Re: Docket No. 50-312  
Rancho Seco Nuclear Generating  
Station, Unit No. 1  
Your Request for Information  
Dated March 6, 1980

SACRAMENTO MUNICIPAL UTILITY DISTRICT

REQUEST FOR INFORMATION DATED MARCH 6, 1980

FIGURE 1

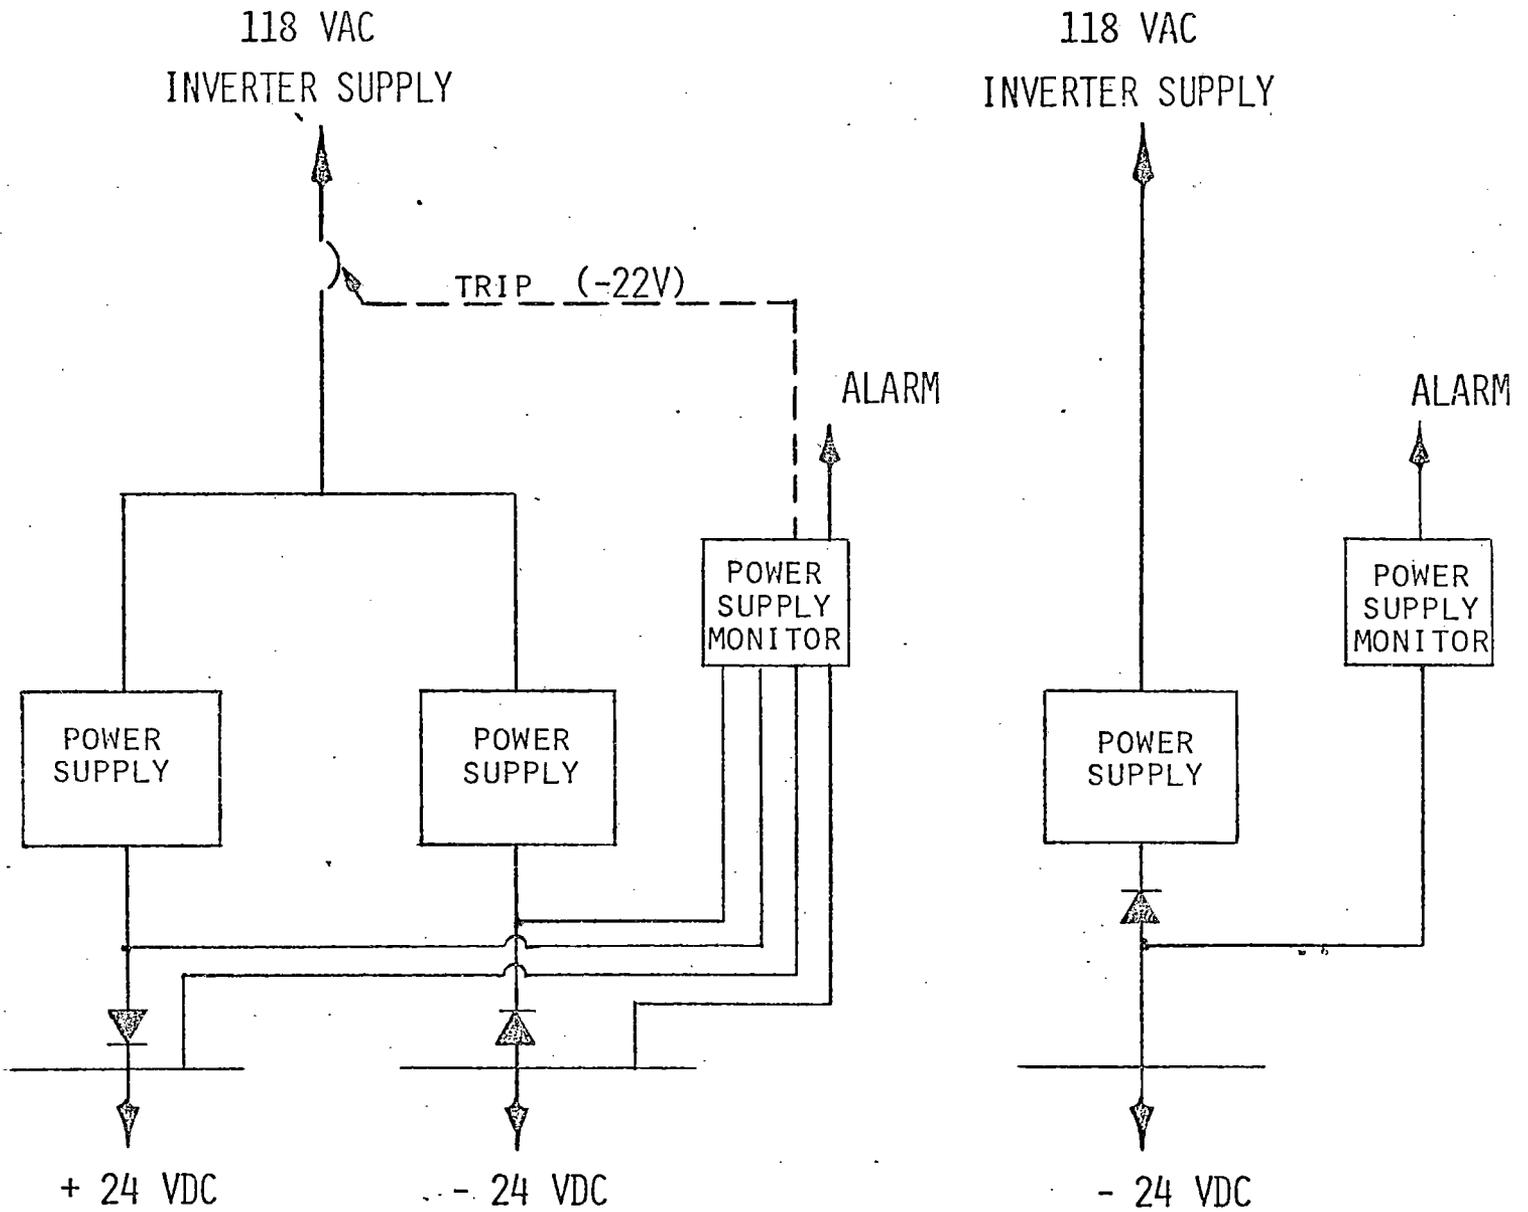
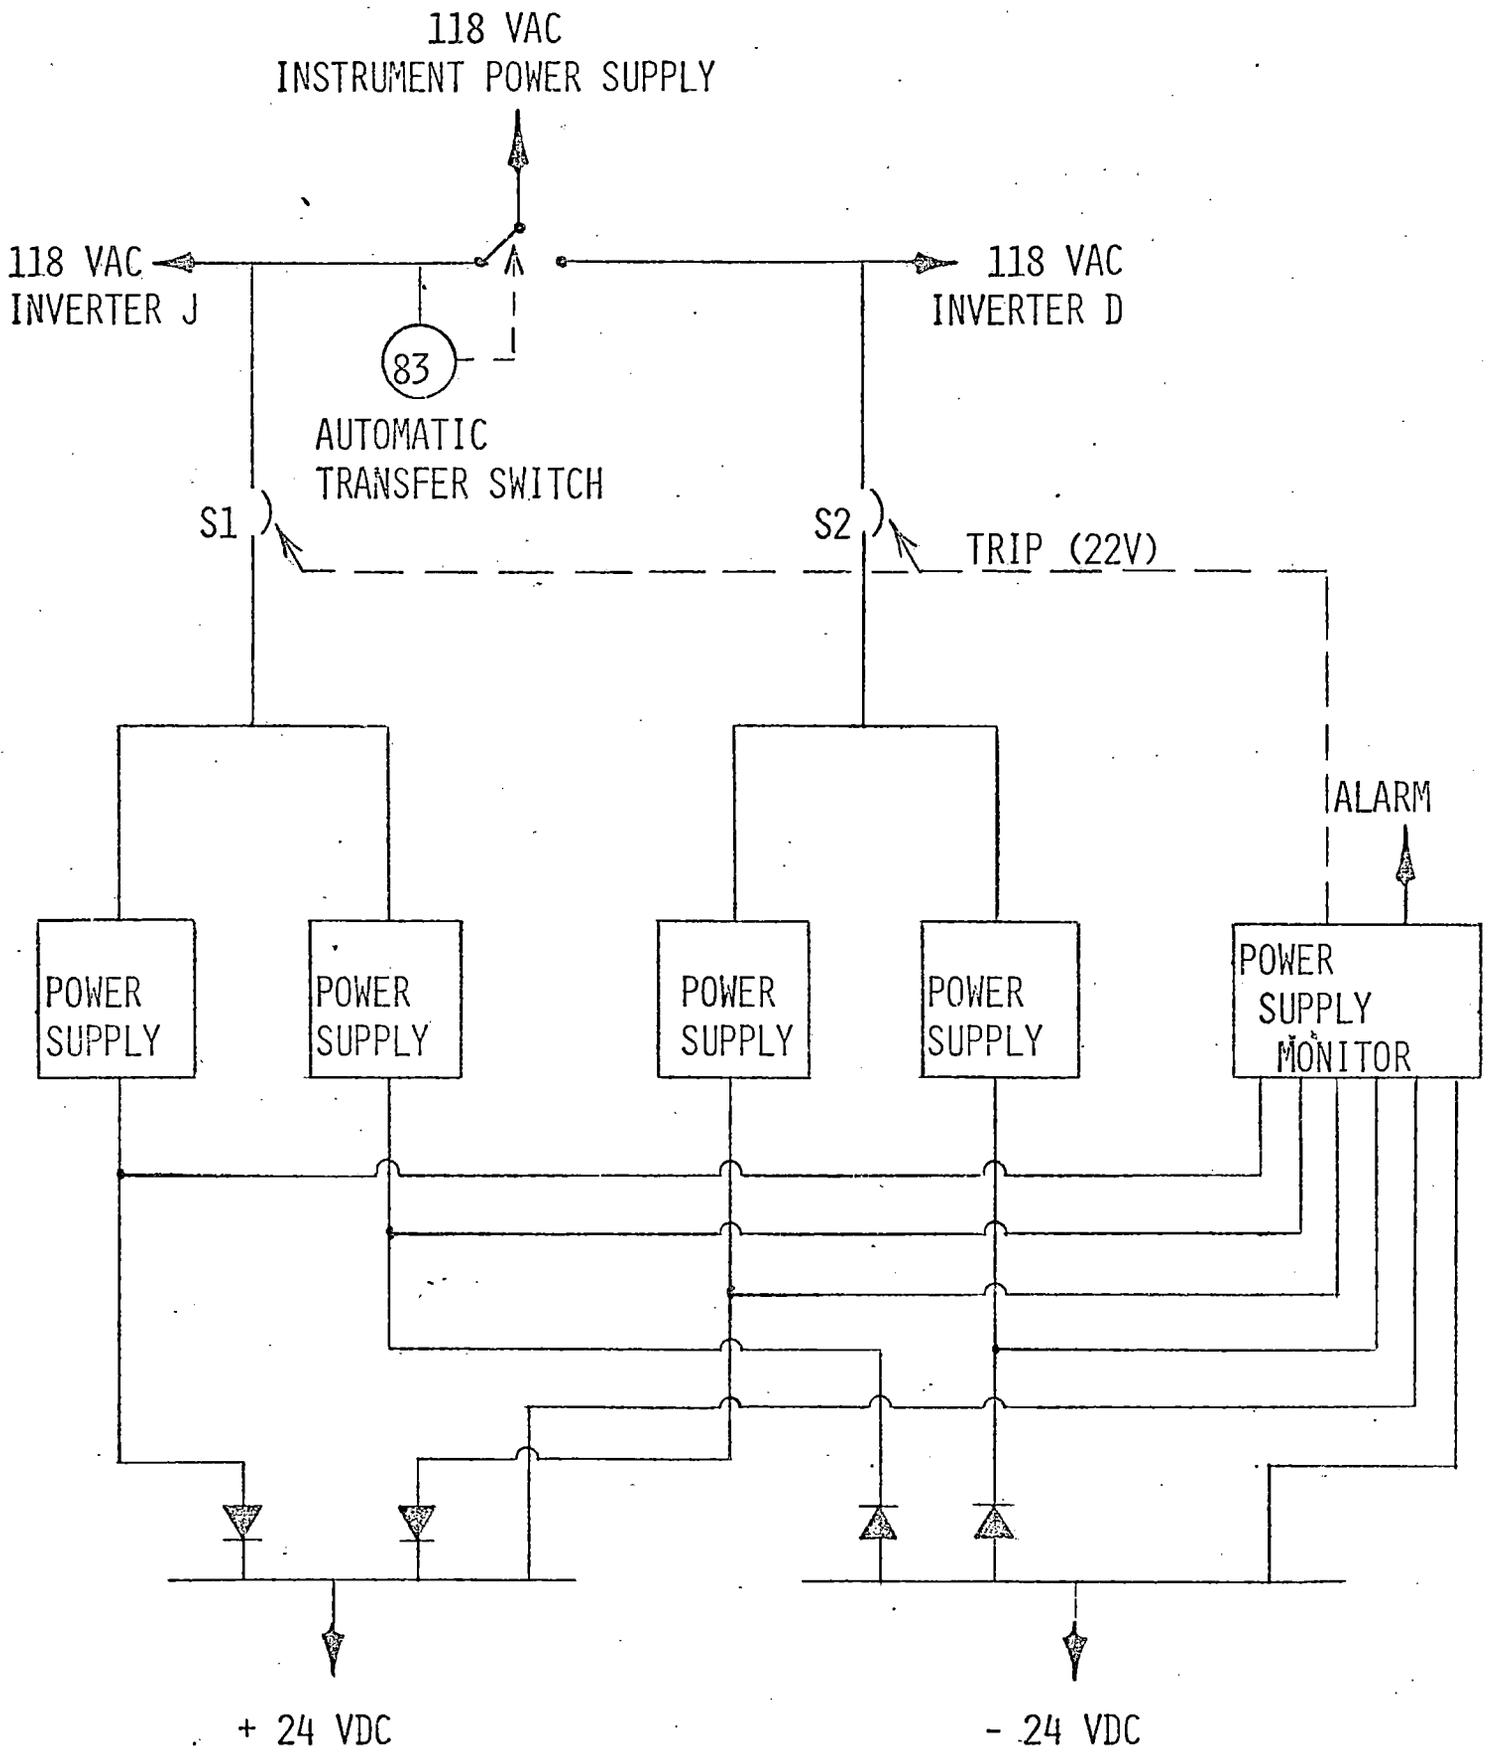
Following these events above, parallel inverter supply was added to the ICS and NNI DC supplies. In addition, an automatic bus transfer was added to the 118 VAC instrumentation supply. See Figure 1 for initial power supply configuration and Figure 2 for modification performed.

FIGURE 3

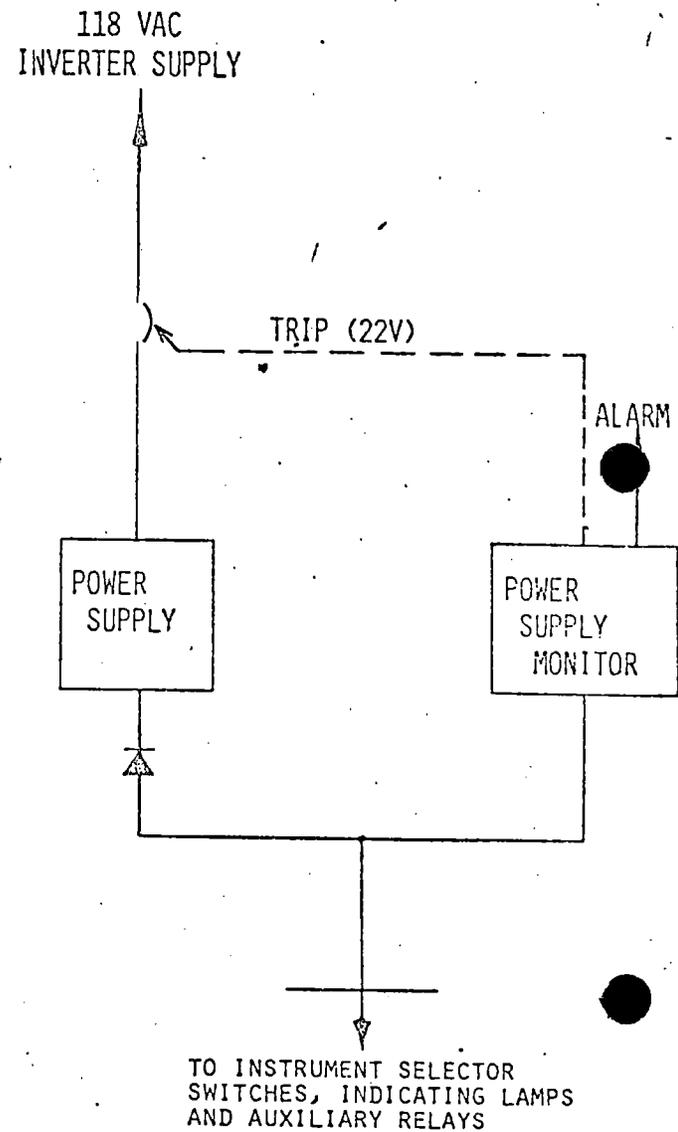
- e. RECOMMENDATION: Provide a separate power supply module for the NNI instrument selector switches, associated indicating lamps and auxiliary relays. This circuit would be similar to that shown in Figure No. 3 attached. This change would not be likely to prevent a plant trip, but it would reduce the quantity of instrumentation lost for a short circuit condition identical to that of March 20, 1978.

FIGURE 4  
1980 POWER SUPPLY MODIFICATION

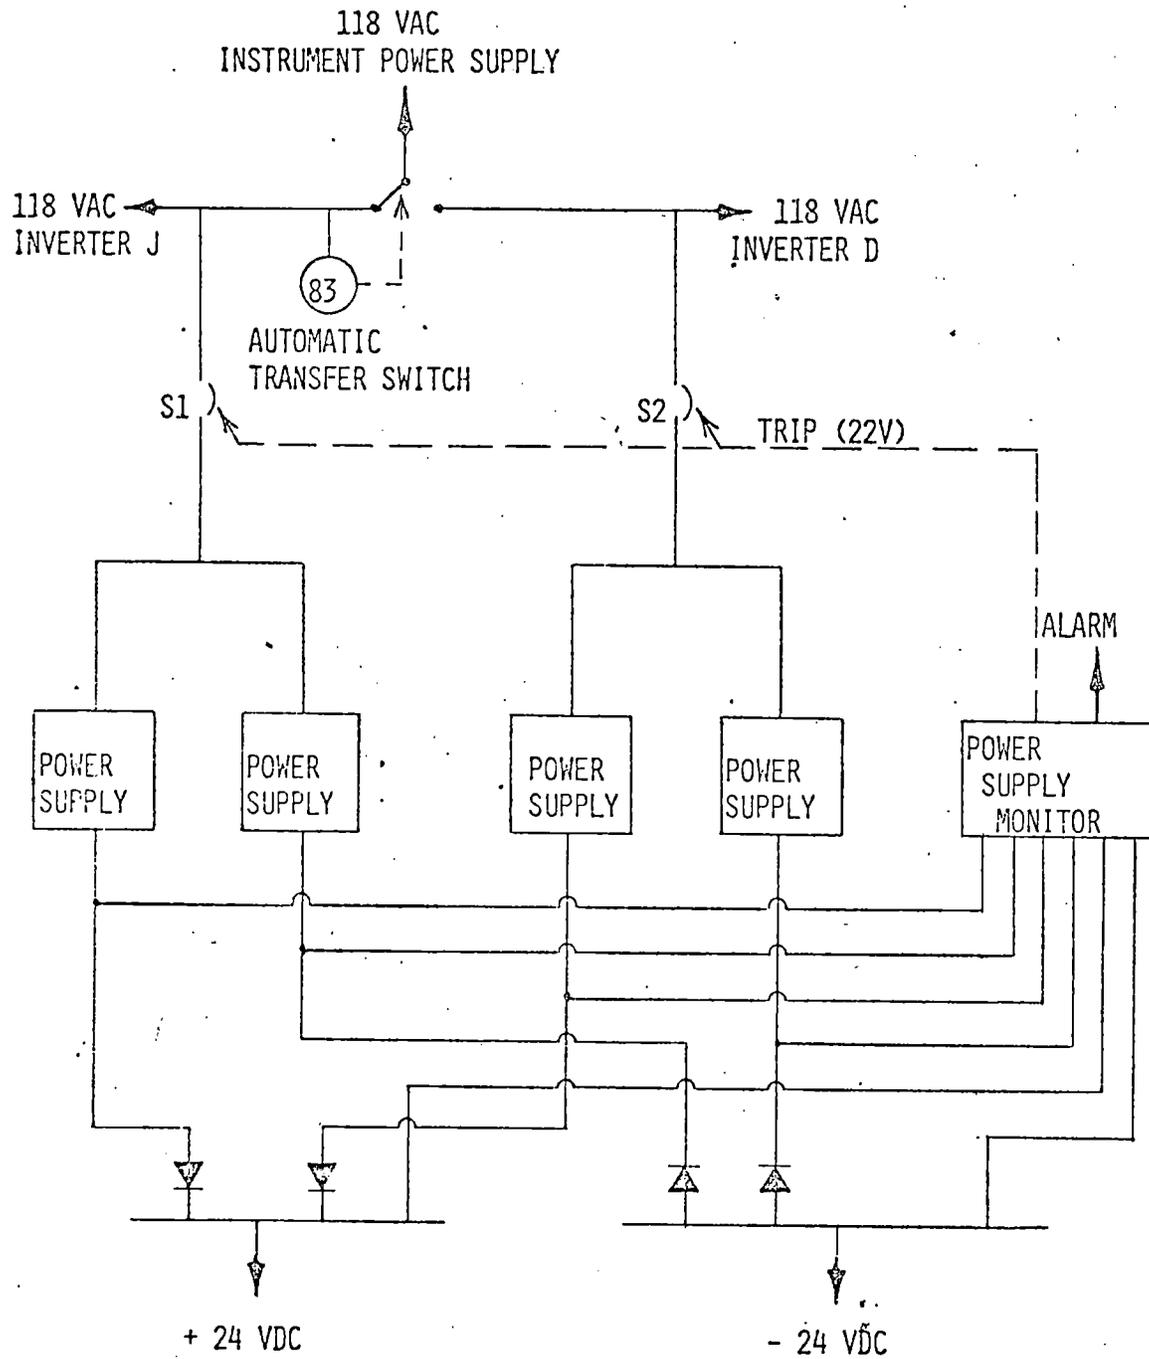
- g. CR-3: Move 120 V ICS X power to a vital bus.

ACTION TAKEN: A design was produced as shown in Figure No. 4. Equipment was ordered and the modifications are being made during the present refueling outage.

RS: At Rancho Seco, NNI-Y, NNI-X and the ICS power supplies receive their input power from both a vital bus, Class I, 118 VAC battery backup inverter and a Class II, 118 VAC battery backup inverter. Figure 4 attached is a typical diagram of either NNI or ICS power supplies.

There are two +24 V power supplies, one being supplied from the vital bus and one supplied from the secondary plant bus. The output from these two +24 V power supplies is auctioneered to supply the load. A loss of either the vital bus supply or the secondary supply will therefore not cause a loss of +24 V. This explanation is the same for the -24V supply. The NNI-X, NNI-Y and ICS power supplies are installed in this manner.

The 118 VAC power supply for NNI or ICS is protected through an auto-transfer switch. This is shown on Figure 4. The auto-transfer switch normal lineup is to the vital bus supply. On decreasing voltage (100V), the auto-transfer switch transfers to the secondary plant bus. This transfer is alarmed in the control room and local indicating lights display from which source the auto-transfer switch is receiving power. Operator action is required to reposition the auto-transfer back to the vital bus.

RS: Figure 4, attached, displays the typical arrangement of NNI-Y, NNI-X and ICS power supplies. As can be seen, each of these power supplies receives its primary source of AC supply from a vital bus. Secondary plant inverters supply backup AC sources. Therefore, SMUD has already modified the NNI and ICS power supplies to meet the intent of this CR-3 long-term corrective action.
